Technical Assessment Report

Review of GenCost 2023-24

Technical Assessment Report No: TAR-2401

Figure 4.1: Capacity Factors for Onshore Wind (Adapted from GenCost 2022-23)

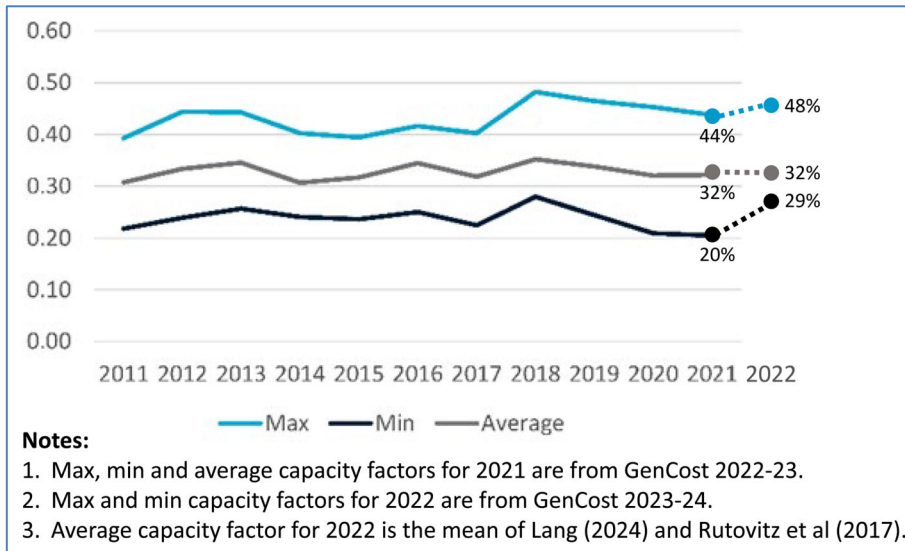
Consequently, the high capacity factor of 48% for onshore wind used in GenCost 2023-24 is not unreasonable when compared with the value of 44% from Figure 4.1, because new wind turbines should have a higher capacity factor than existing turbines. Nevertheless, Hughes (2012) does note that the capacity factor of newer (larger) turbines is less than that of older (smaller) turbines. Therefore, it would be prudent to adopt the 44% value in Figure 4.1.

However, the low capacity factor of 29% appears to be untenable because it is too near to the average value as discussed below.

Furthermore, assuming a normal distribution and using a high of 48% and an average of 32%, would result in a low capacity factor of 16%. However, using the 20% value presented in Apx Figure D.1 of GenCost 2022-23 (Figure 4.1 above) is slightly high, but it is not unreasonable.

- The high capacity factor of 48% presented in GenCost 2023-24 is not unreasonable but it would be prudent to adopt the 44% value in Figure 4.1 because Hughes (2012) has highlighted that the capacity factor of newer (larger) turbines is less than that of older (smaller) turbine.
- An average capacity factor of 32% is reasonable.
- The low capacity factor of 29% is untenable because it is too near to the average value 32%, and it is not consistent with a normal distribution. Therefore, it is recommended that the 29% value be replaced by the 20% value presented in Apx Figure D.1 of GenCost 2022-23 (Figure 4.1 above).

- High capacity factor = 44%.
- Average capacity factor = 32%.
- Low capacity factor = 20%.

Figure 4.2: Capacity Factors for Large-Scale Solar PV (Adapted from GenCost 2022-23)

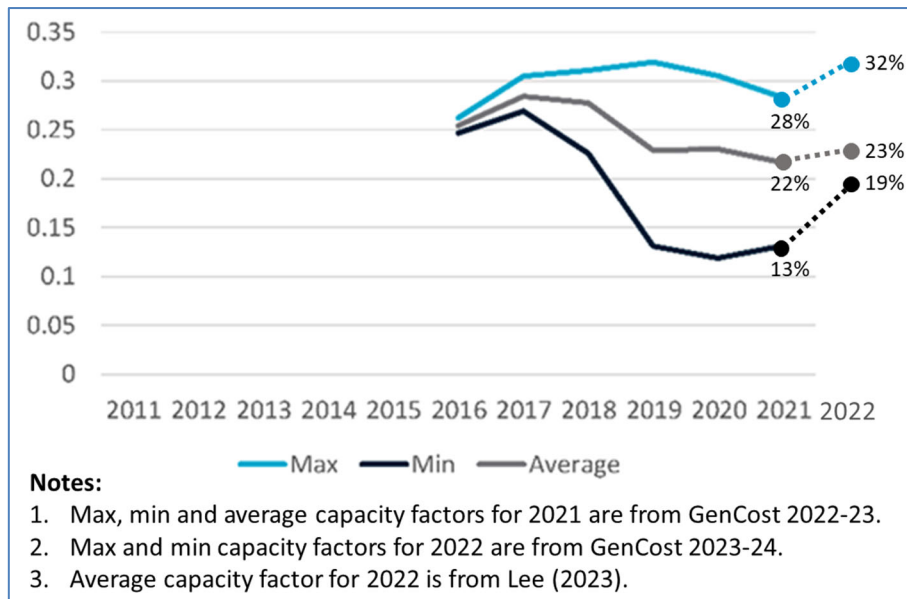
However, GenCost 2023-24 Apx Table B.9 Data assumptions for LCOE calculations shows a high capacity factor of 32% and a low factor of 19% for large-scale solar PV. Furthermore, Figure 4.2 (adapted from GenCost 2022-23 Apx Figure D.1) shows that the maximum, minimum and average capacity factors for large-scale solar PV are 28%, 13% and 23% respectively.

- a. High capacity factor = 29%.
- b. Average capacity factor = 23%.
- c. Low capacity factor = 19%.

Figure 4.3 Capacity Factors for Large-Scale Solar PV (Adapted from Lee, 2023)
Note: Comments in red have been added to the original diagram.

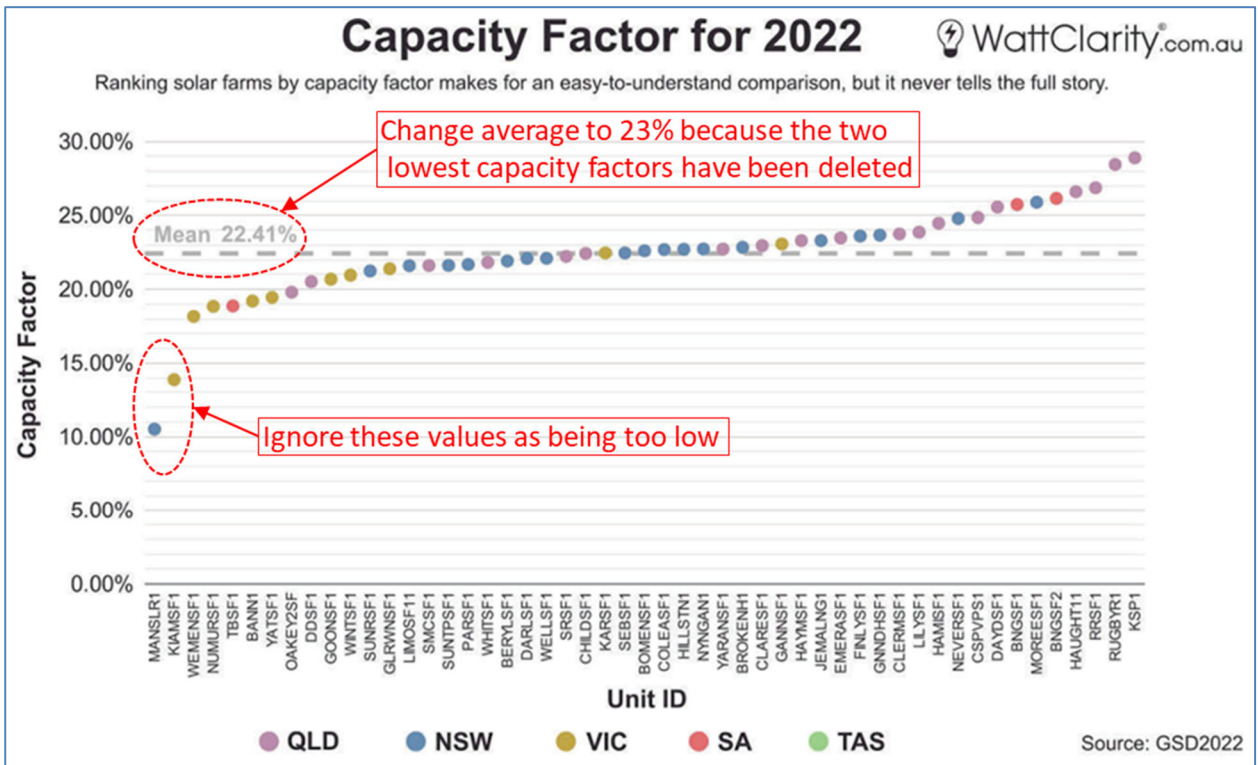
Additionally, Lee (2023) presents capacity factors shown in Figure 4.3 that are similar to the high and low values in Figure 4.2. Consequently, if we were to ignore the two low values in Figure 4.3, the resulting capacity factors would be 29%, 18% and 23% for the maximum, minimum and average respectively.

The low capacity factors of 18% and 19% in Figure 4.3 are near to the low value of 19% used in GenCost 2023-24. However, the high capacity factor of 32% in GenCost 2023-24 is 10% greater than the high value of 29% presented in Figure 4.3. Consequently, it is suggested that the high capacity factor of 29% from Figure 4.3 be used in GenCost 2023-24.

Figure 6.1 Comparison of LCOE for Nuclear, Onshore Wind and Large-Scale Solar PV (Source: IEA, 2020)
Note: Red ellipses have been added to highlight new-build nuclear, onshore wind and solar PV.

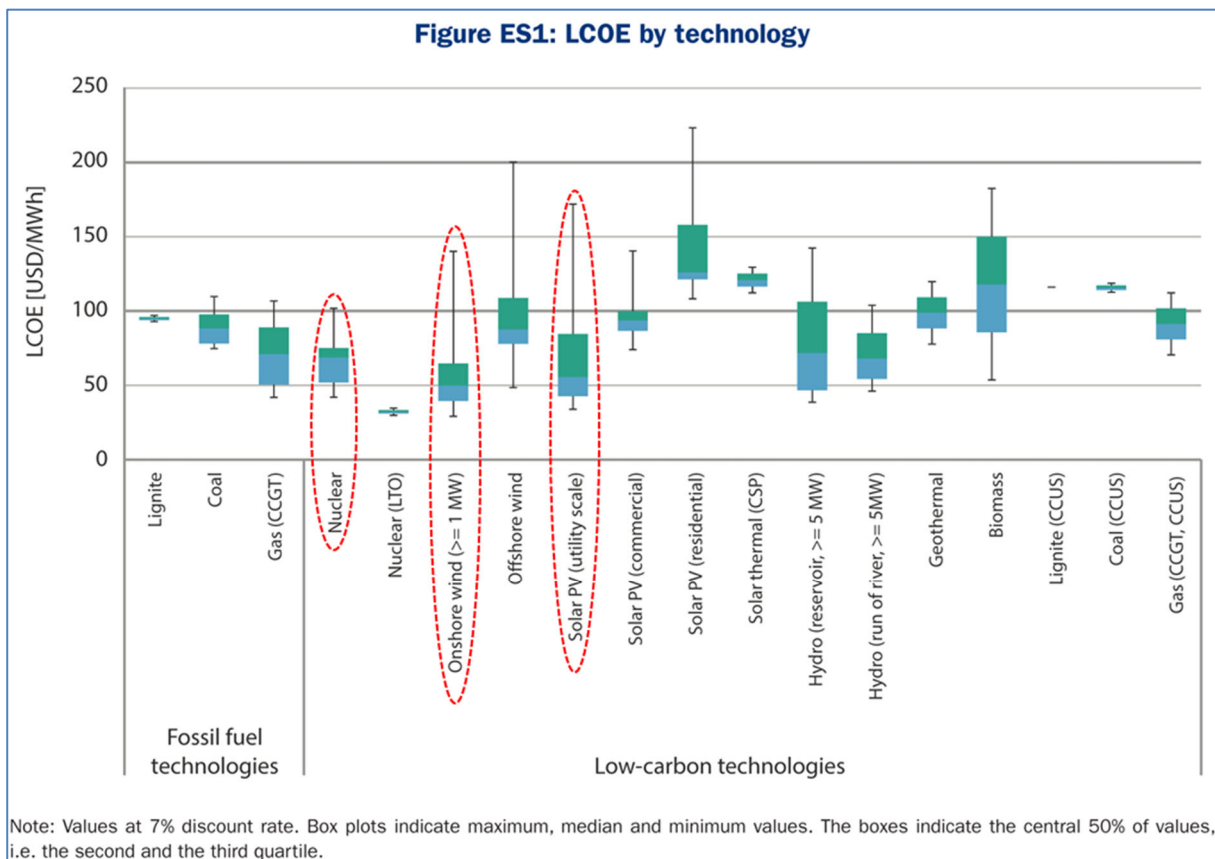
IEA (2020) states that new-build nuclear has a similar LCOE to onshore wind and large-scale solar PV as shown in Figure 6.1.

Furthermore, in relation to nuclear, GenCost 2023-24 only considers small modular reactor (SMR) technology, and its costs are based on a single (and now cancelled) project in Utah, USA. This has resulted in a very high LCOE estimate. However, GenCost 2023-24 does not evaluate other types of nuclear power (including SMR’s) that have been deployed elsewhere. For example, in China (Reuters, 2023) and Russia (Power Technology, 2021) have deployed SMR’s.

It is evident from the above that GenCost 2023-24 only considered one cancelled SMR plant for its estimate of the LCOE, which has resulted in a very high cost estimate. Consequently, if GenCost 2023-24 is to consider nuclear, then it is recommended that not only the SMR technology deployed in China and Russia be considered, but also that the more diverse range of nuclear technology presented in IEA (2020) be considered.

Alternatively, it is suggested that GenCost 2023-24 delete nuclear from its LCOE calculations.
